MUSEUM ROOF REPLACEMENT

ADDENDUM NO. 1

October 18, 2024

Contract No. CH 2024-42

CITY OF HASTINGS ENGINEERING DEPT.		
	SCALE: N.T.S.	CONTRACTOR: T.B.D.	DRN. BY: CM
	DATE: 10/18/24	WORK ORDER: CH00047	APPRD. BY: XXX
	CH 2024-42 Museum Roof Replacement		
Addendum 1			DRG. NO. 1 of 1

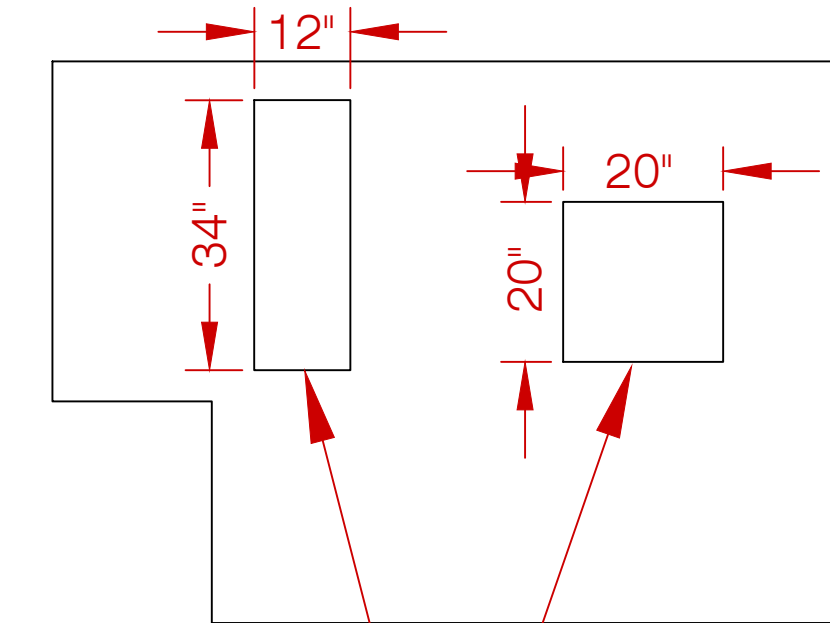
Addendum 1:
Roof areas excluded
from project

- Addendum 1: Bid Item #2
- Owner to disconnect HVAC units,
 - Contractor to remove units from roof;
 - Owner to dispose of units;
 - Contractor to remove curb, fill in void in the metal roof deck

Roof area excluded
from project

RTU-2 vent openings
(conduit openings not shown)

Replacement Area
Approx. 19,200 SF

- q. There are two rooftop HVAC units that are no longer used (see drawing from Addendum 1. Owner to disconnect the units and drain the refrigerant. Contractor to lift units off of roof. Owner to dispose of units. Contractor to remove metal curb left behind. Contractor to fill in structural deck voids to match original metal roof deck.
